SERVICE BULLETIN

NO113B DATE 05-01-99

McDONALD'S VERTICAL CONTACT TOASTER (VCT-200) Conveyor Motor Replacement Kit (P/N 7000204) Phase II

INSTALLATION INSTRUCTIONS VCT-200 GEAR MOTOR KIT P/N 7000204

Figure 1. Replacing Drive Motor and Fan Blade

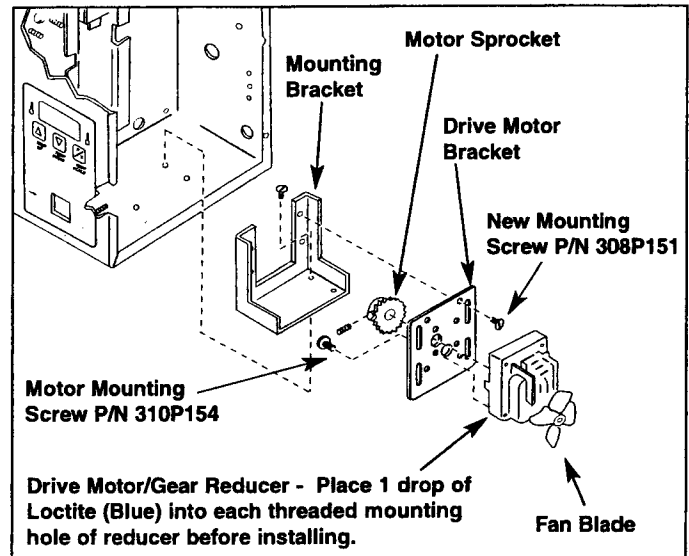
1. Disconnect the motor wires and remove the drive motor and drive motor bracket (Figure 1). Discard the four 8-32 x 5/16" mounting bracket screws.
 2. Remove the motor sprocket using a hex wrench.

Figure 2. Conveyor Motor Sprocket and Fan Assembly Instructions

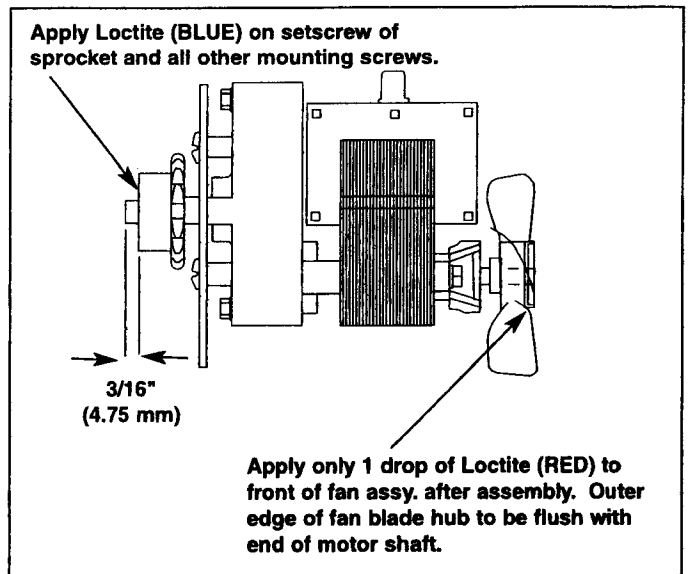
5. Attach the motor sprocket to the gear reducer as shown in Figure 2.
- NOTE: Be sure sprocket setscrew is positioned on the flat of the gear reducer shaft. Maintain the 3/16" dimension as shown in Figure 2. Apply Loctite (Blue) to threads of setscrew and tighten securely.*
